# Architectural Review and Historic Preservation Board Agenda Report

File: AR 19-18

RE: AR 19-18 (Truhe Office) -- Cohasset Road at Elisha Court, APN 015-120-076

**SITE PLAN**

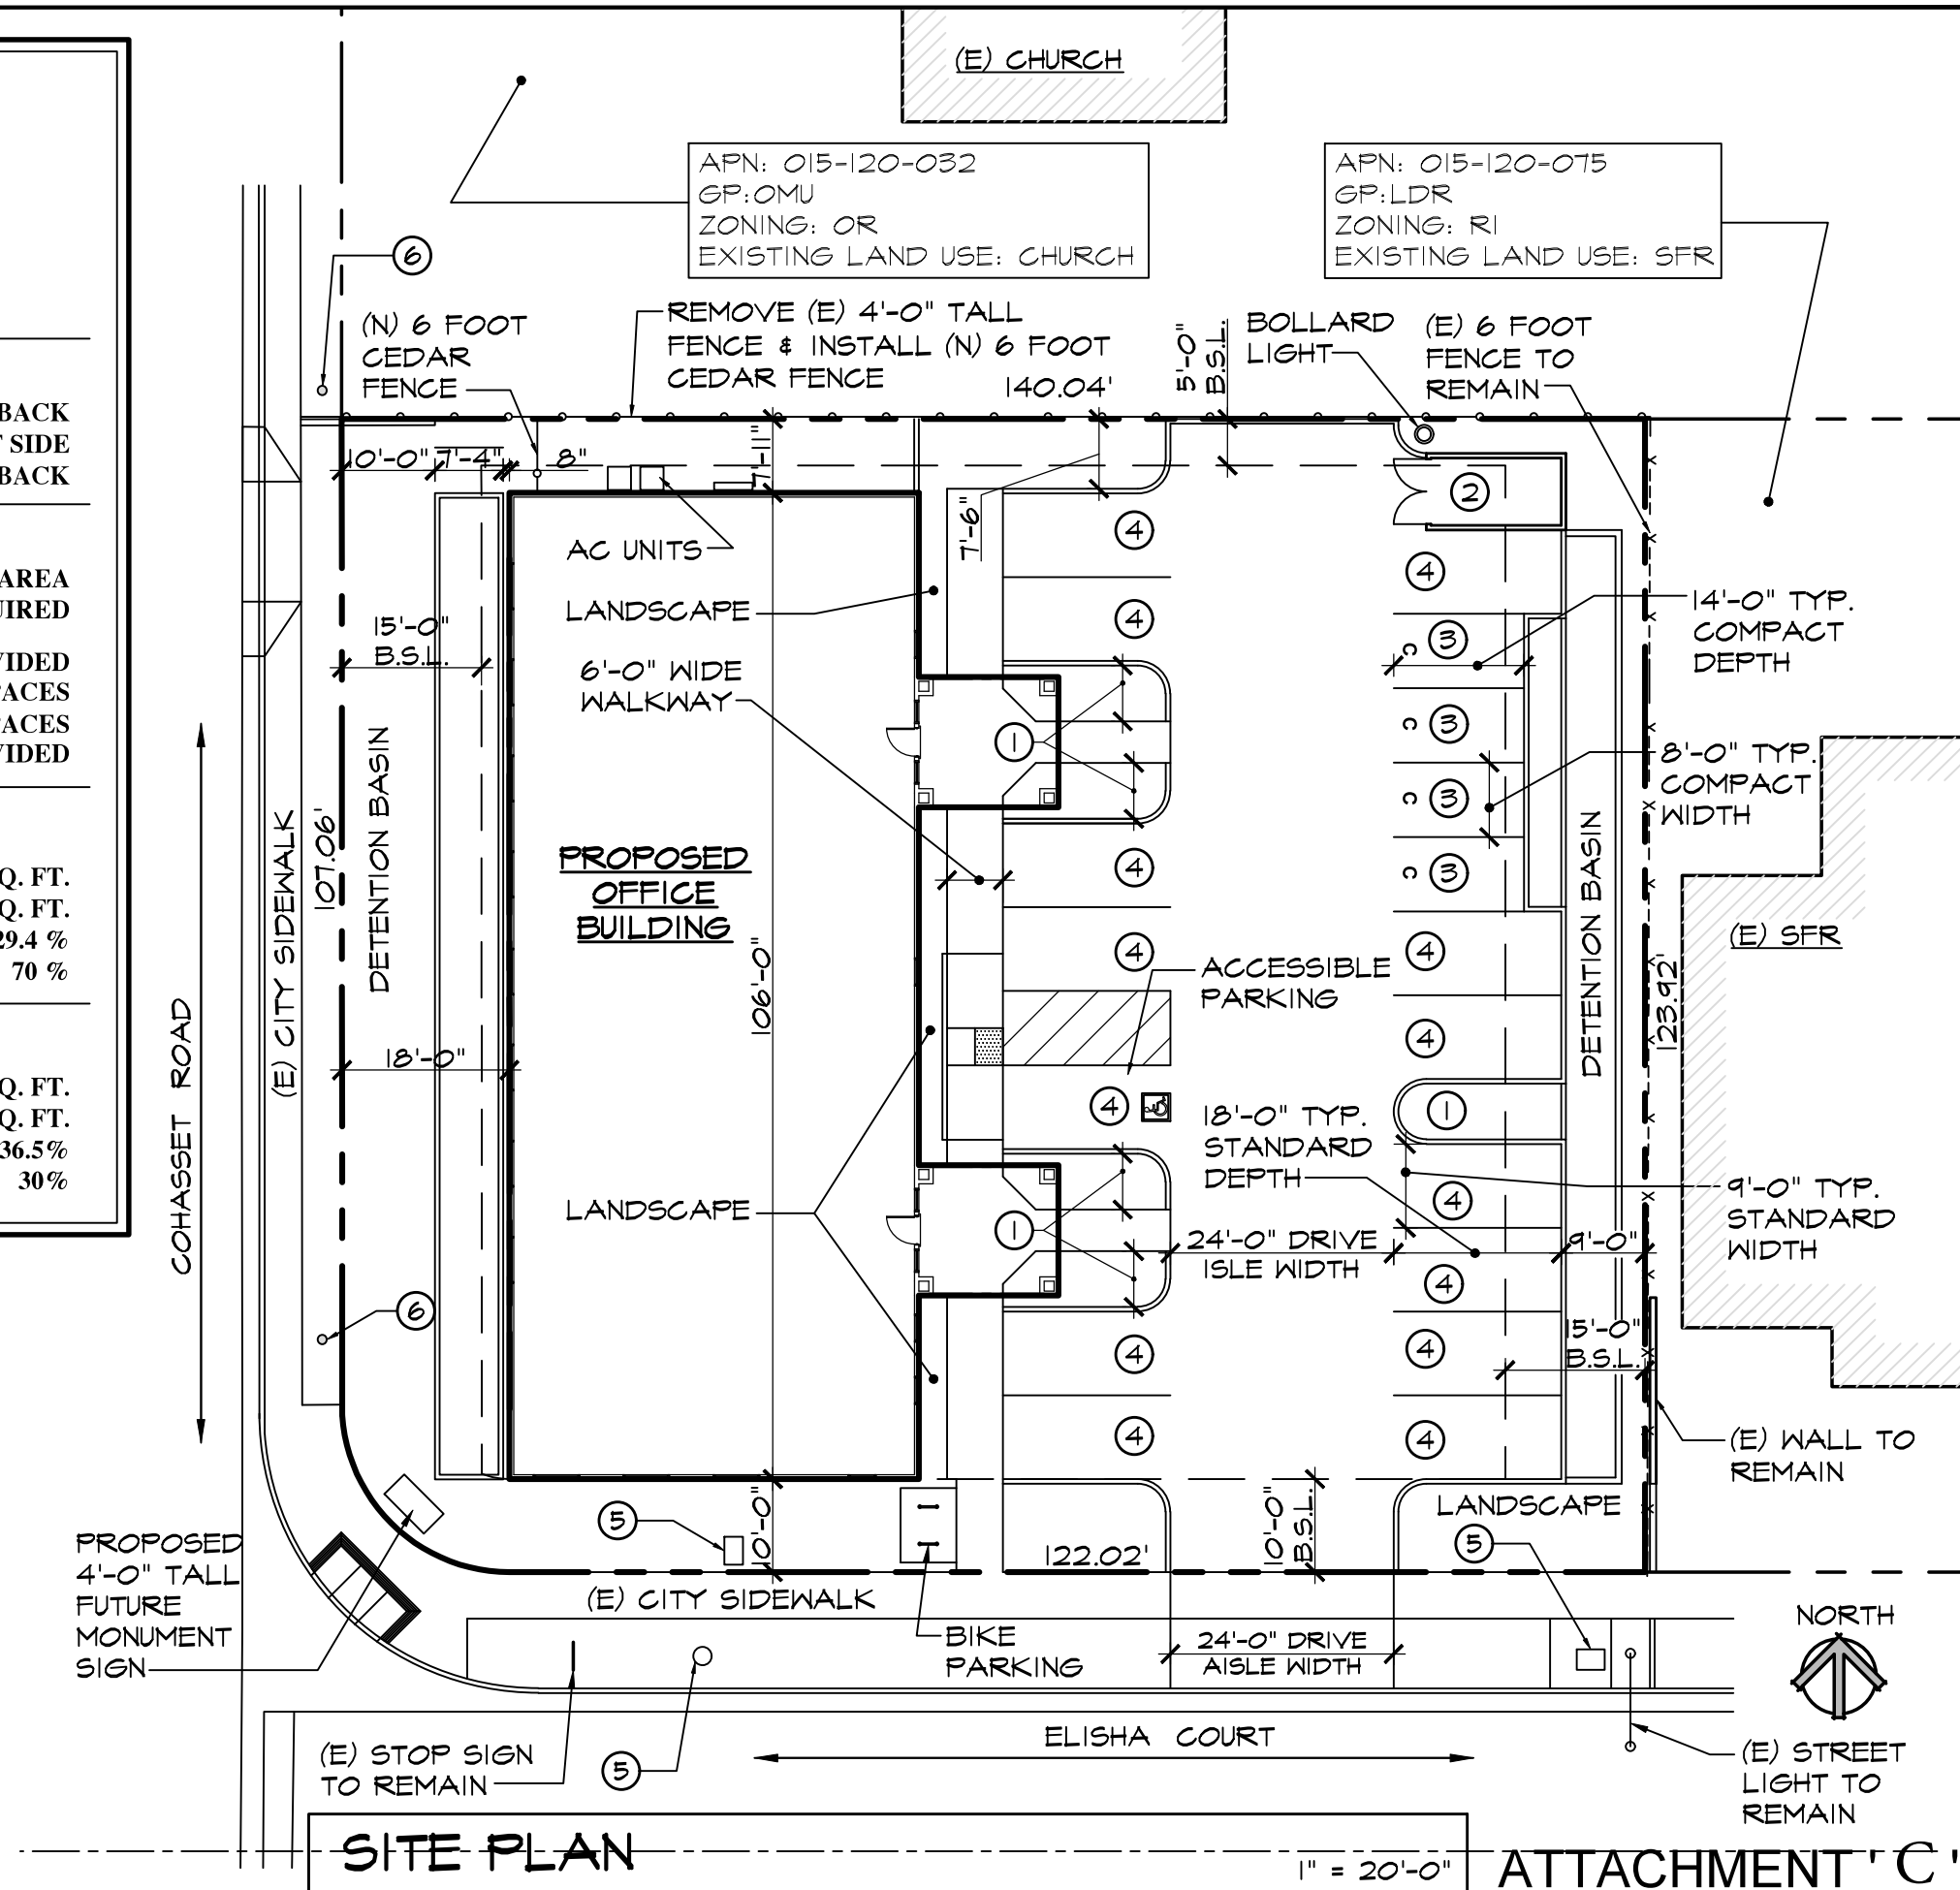
The proposed building would be set back 18 feet from Cohasset Road and 10 feet from Elisha Court (see **Attachment C**, Site Plan). A new parking area would be located to the west of the proposed building. Of the 18 spaces mentioned, one is accessible. The required number of spaces for the proposed office is 14. Additionally, four bike parking spaces are provided on the south side of the structure, adjacent to Elisha Court.

The design is challenged by several DGs that encourage a pedestrian orientation and discourage providing excessive automobile parking (DGs 1.1.13, 1.1.14, 1.1.15 and 2.1.27). The design encourages visitors to walk through the parking area to enter the building, resulting in partial consistency with DGs 2.1.21 and 2.1.22. Bicycle parking is located close to the main entrance (DG 2.1.32), though it would not be covered and protected from the elements as encouraged by DG 2.1.31. The scale and character of the project would not overwhelm the neighborhood (DG 1.2.13), and its massing, scale, and form respond to the context of surrounding structures (DG 3.2.12).

To achieve better consistency with Design Guidelines, Condition #5 has been added to require a structural cover over the bicycle parking area. Because of consistency with the surrounding auto-oriented neighborhood context, it is somewhat justified for the site design to be auto-oriented. Therefore, with conditions to improve DG consistency, staff supports approval of the project.

4. Proposed project signage shall be permitted through a separate sign permit in compliance with CMC 19.74 (Signs).
5. Provide a structural cover over the bicycle parking area, or relocate the bicycle parking to a covered location within 20 feet of the front building entrance.
